December 1, 2010

RE: MARCO'S PIZZA SELA#1
2349 EAST GAUSE BLVD
SUITE 1
SLIDELL, LA 70469

EXISTING
1HR FIRE
RATED
WALL.

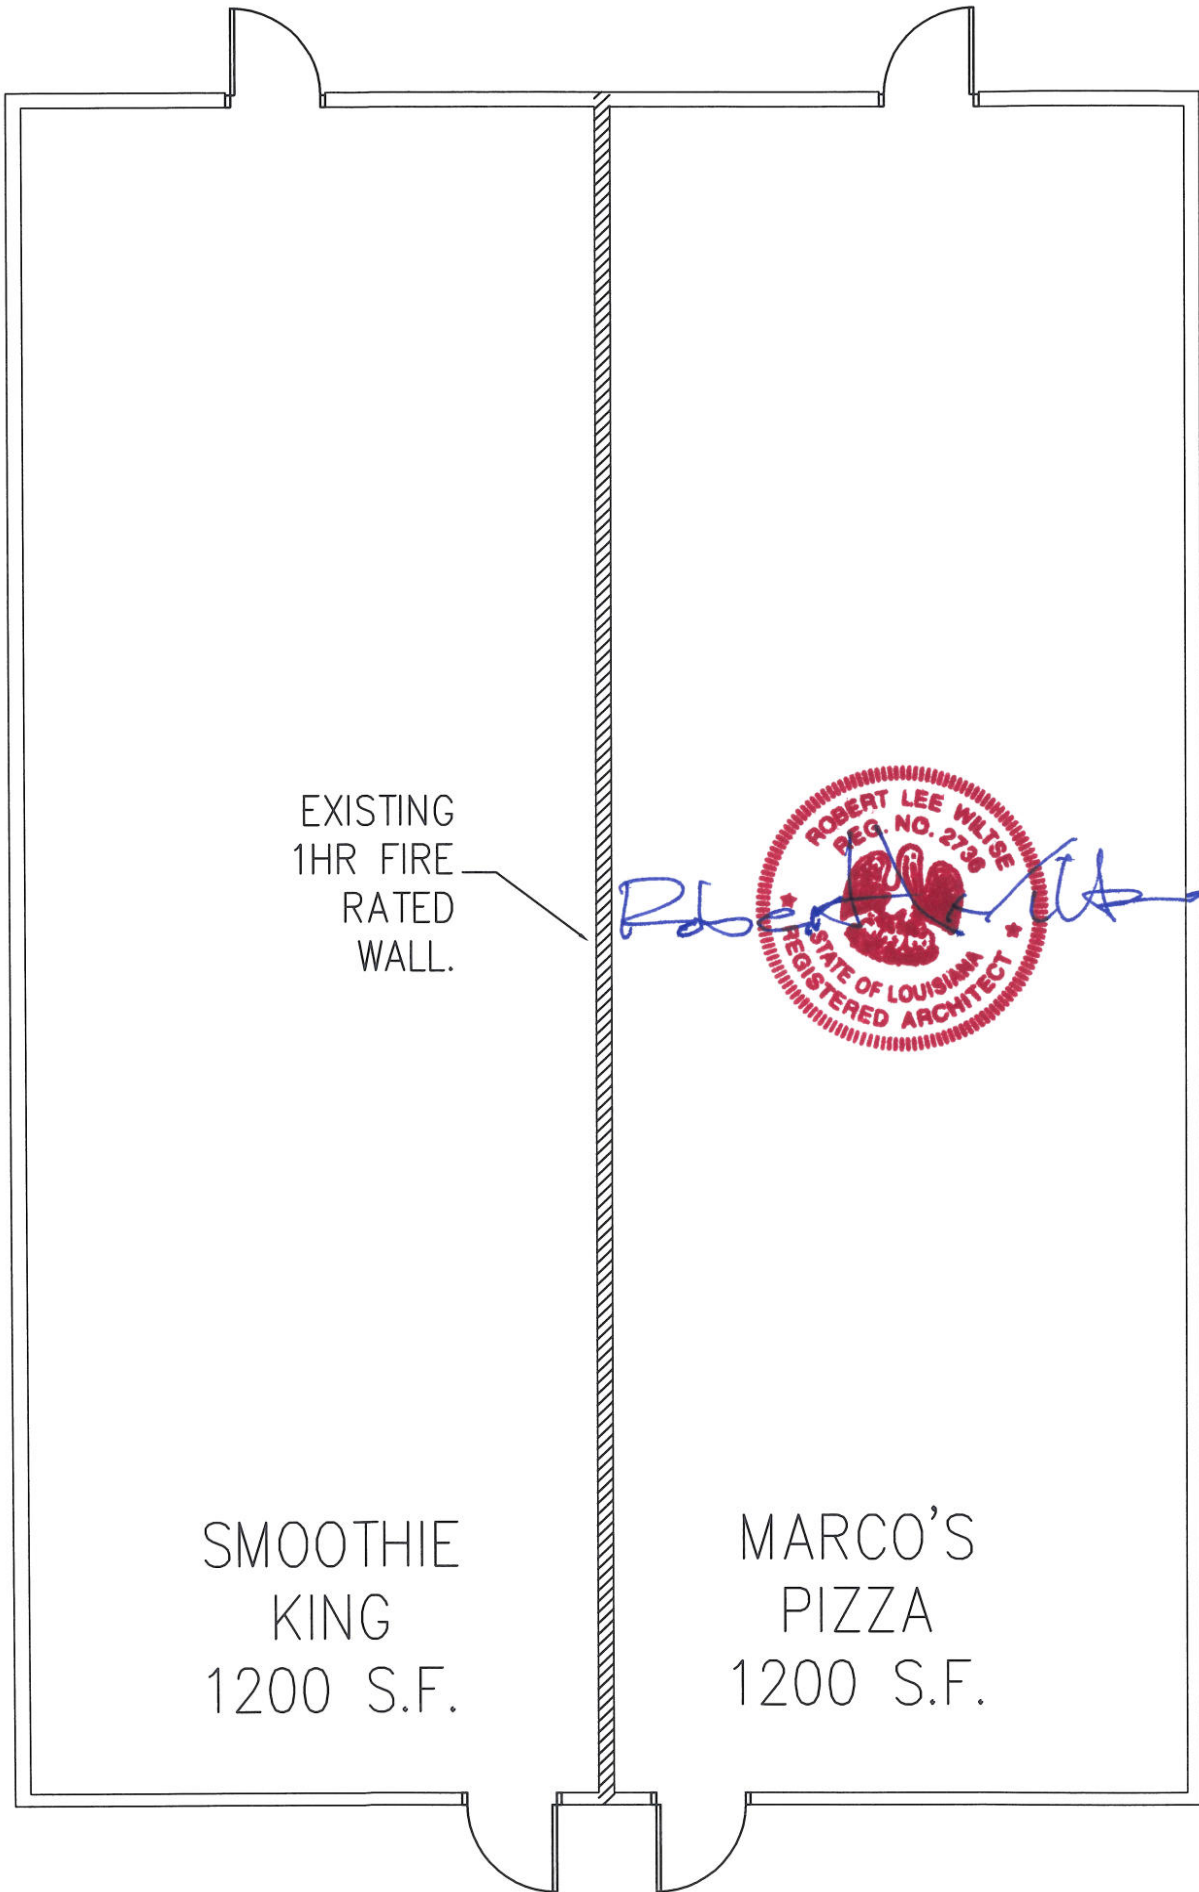
With regard to the above referenced project, the existing demising wall between Suite 1 and Suite 2 was incorrectly labeled on our construction drawings. The construction drawings showed this existing demising wall as an existing 2-hr rated wall. This wall should have been labeled as existing 1-hr. rated wall. Please see attached drawing.

The current tenant in Suite #2 is a Smoothie King restaurant, also the owner of the building; Smoothie King has the same square footage as the new Marco's Pizza, 1200 s.f. Both Smoothie King and Marco's Pizza would be the same occupancy, Assembly under 50 occupants – Business. According to IBC 2006, table 508.3.3, there is no separation required between the same occupancies. Therefore a 1-hr. rated wall complies with the IBC 2006.

Instructions have been provided to the contractor to maintain the existing 1-hr fire rating.
